**TOWN OF NEWBURGH  
PLANNING BOARD  
TECHNICAL REVIEW COMMENTS**

**PROJECT NAME:** DARRIGO SOLAR  
**PROJECT NO.:** 19-24  
**PROJECT LOCATION:** SECTION 86, BLOCK 1, LOT 96  
**REVIEW DATE:** 26 JANUARY 2024  
**MEETING DATE:** 1 FEBRUARY 2024  
**PROJECT REPRESENTATIVE:** ARDEN CONSULTING

Subject: Darrigo Solar Farm Landscape Plan Comment Response Memo  
Comments Received by Email (Town Project Number 2019-14)

# AMENDED 5 MW AC SOLAR FARM SITE PLAN FOR DARRIGO 84 LAKESIDE AVENUE TOWN OF NEWBURGH – ORANGE COUNTY, N.Y.

**2 DECORATIVE METAL FENCE PANEL**  
SCALE: NTS  
CROSS REFERENCE: NONE

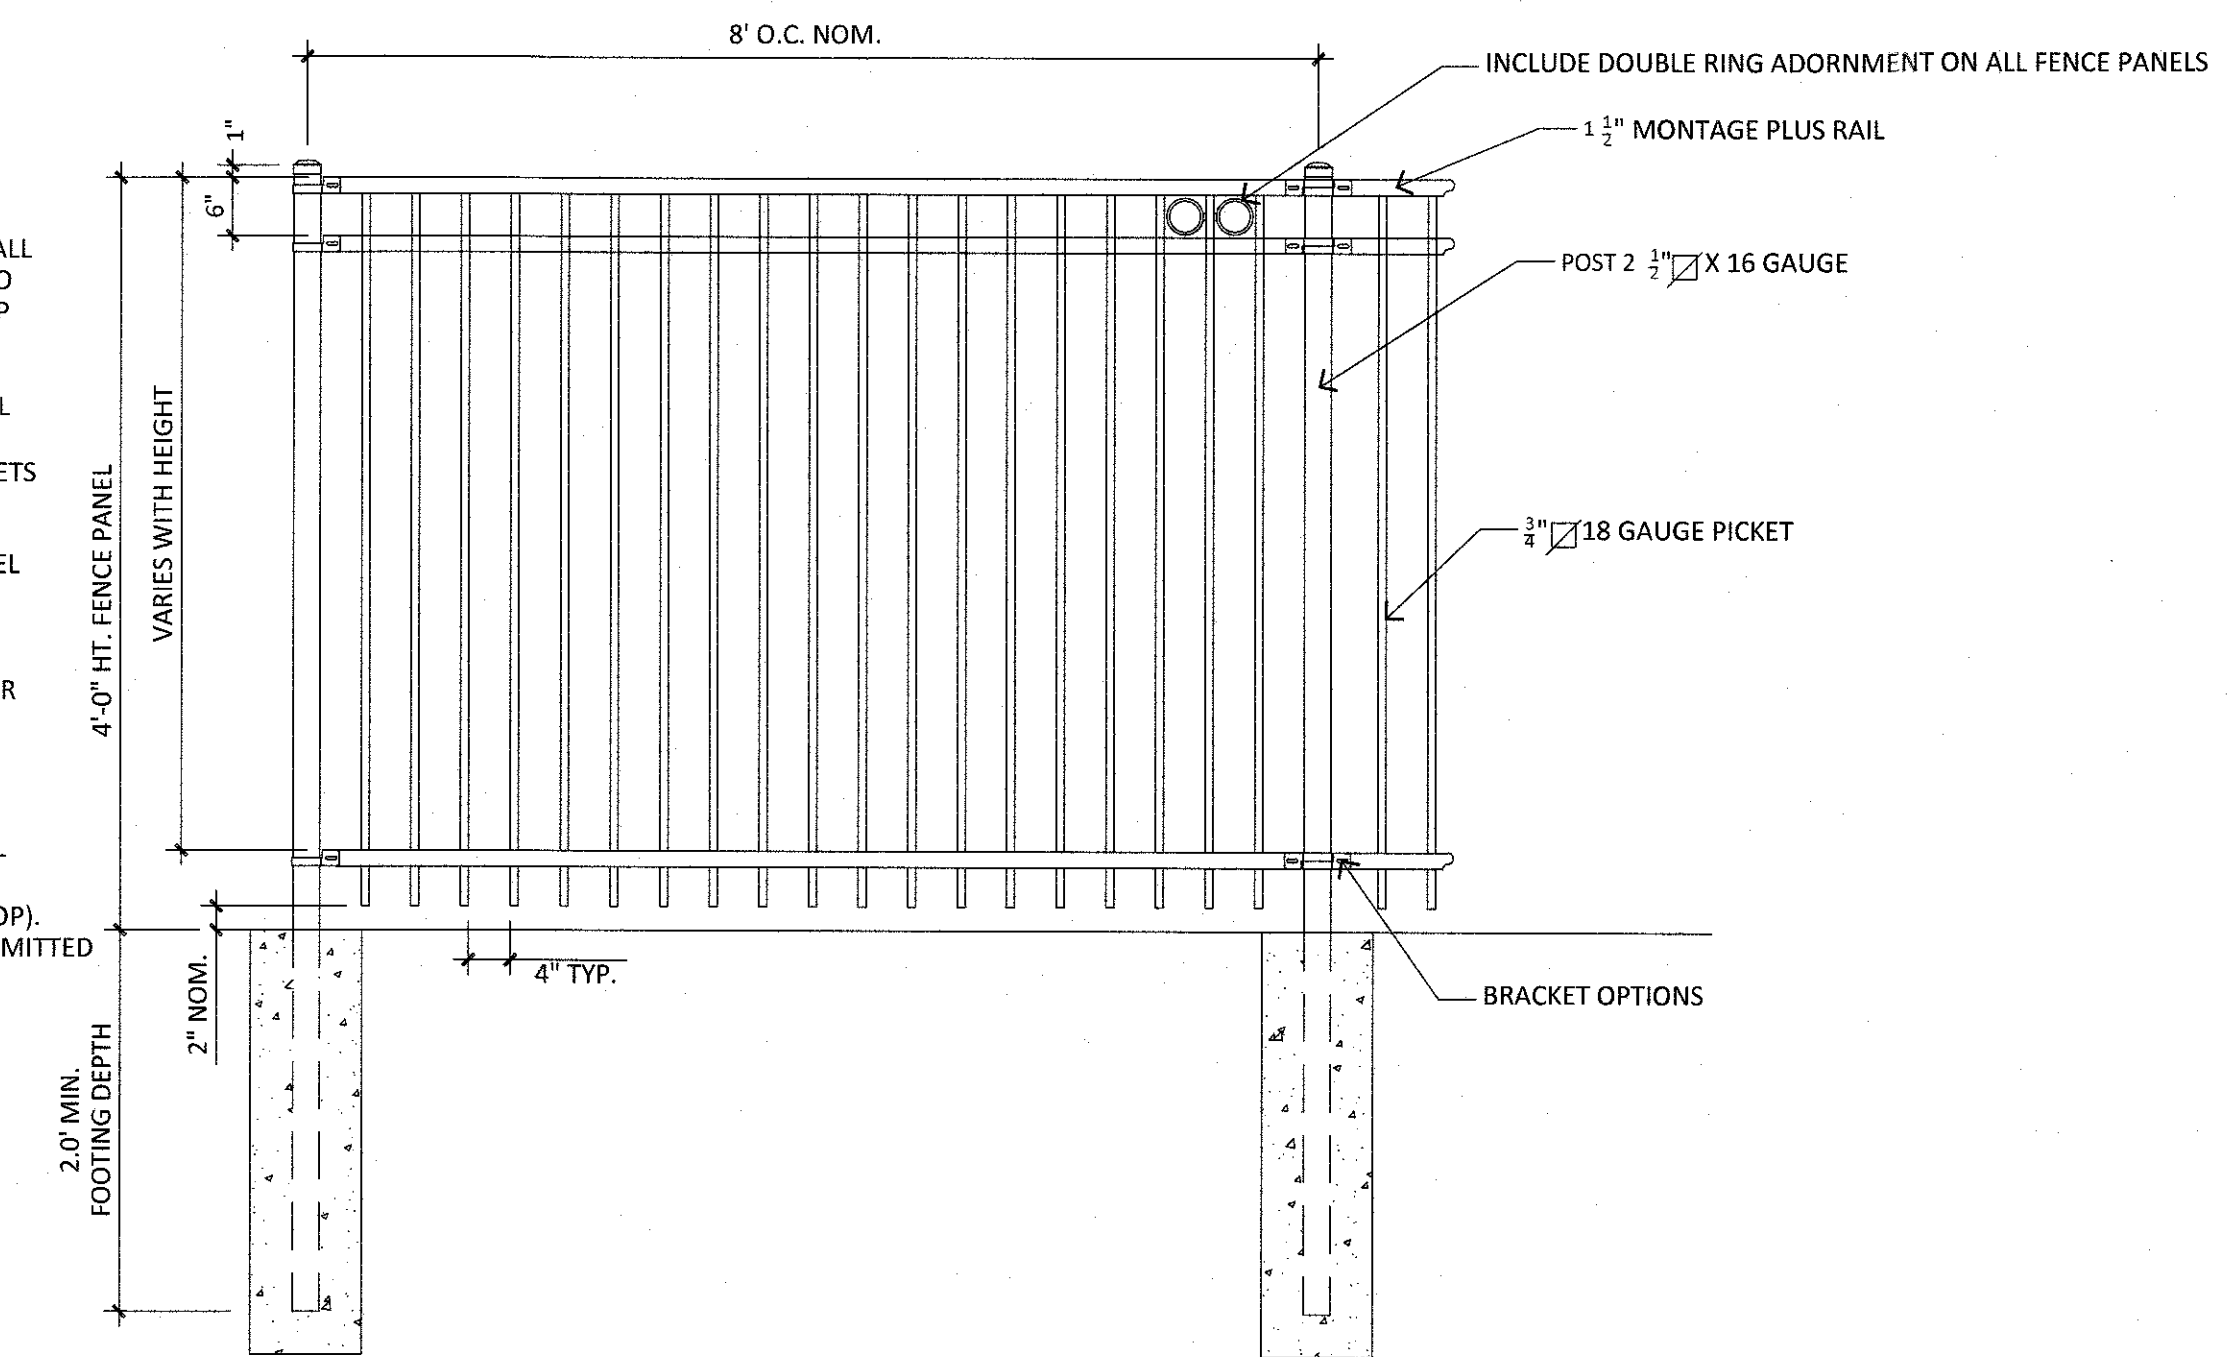
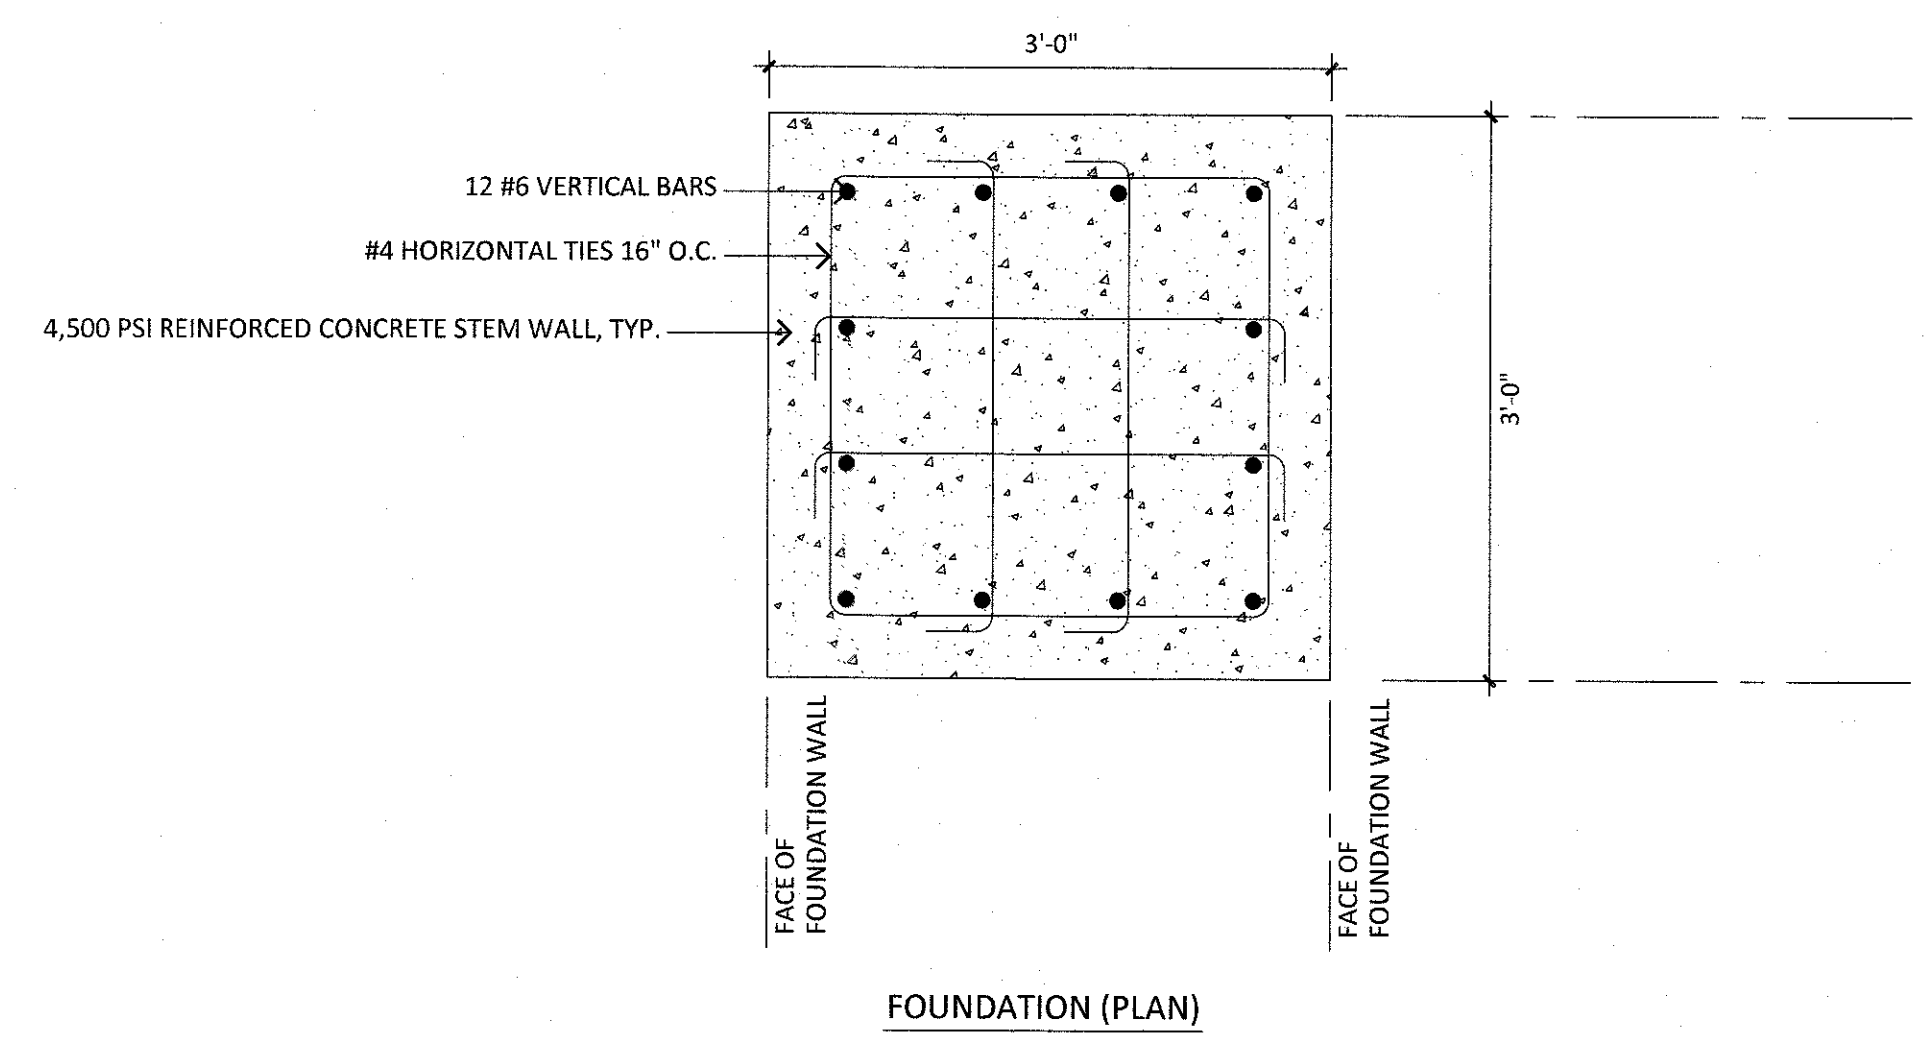
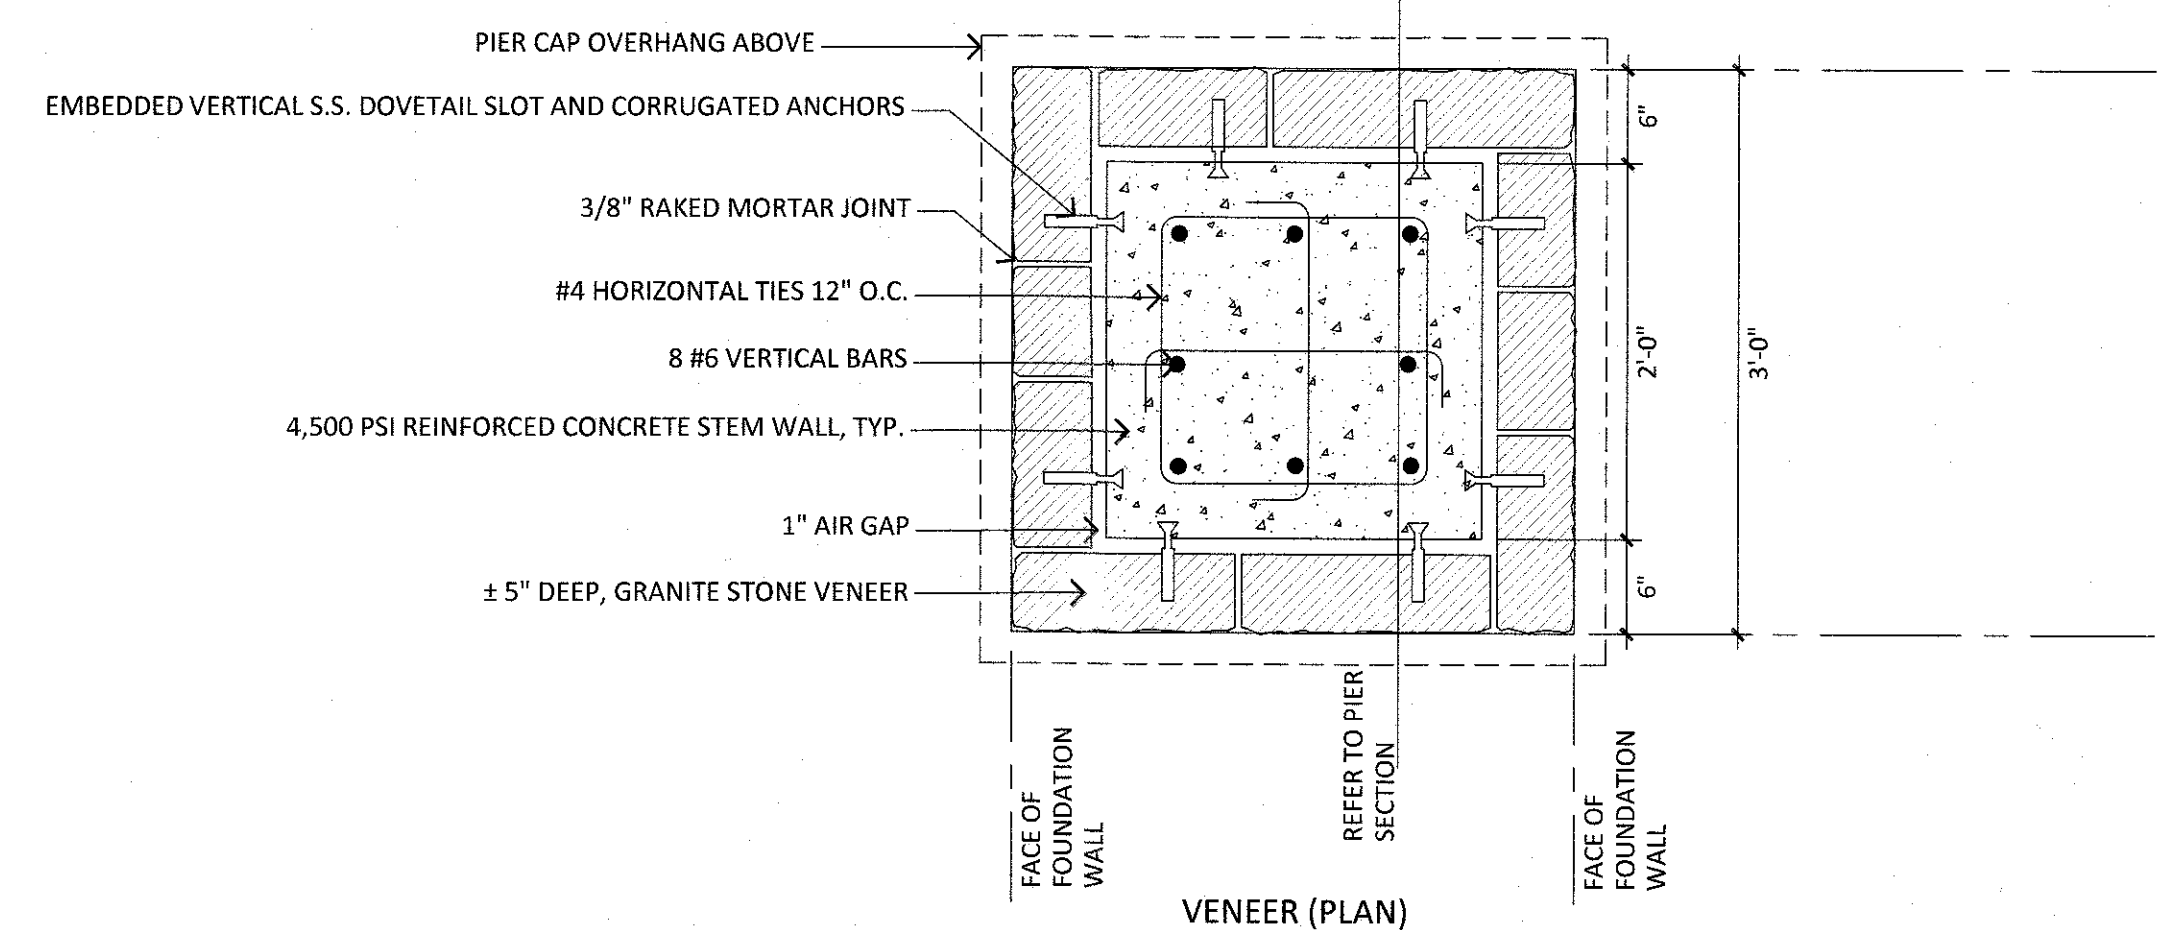
5. No fence details were included. Please include a detail for the proposed fencing at the lakeside road entrance. Fence and gate details have been added on Sheet L-502.

5. Please include a detail for the proposed fencing at the Lakeside road entrance. This fence will be highly visible from the road and it should be aesthetically pleasing.

5. No fence details were included. Please include a detail for the proposed fencing at the lakeside road entrance.
6. Please forward the enlarged planting plan so we can make sure this comment was addressed.
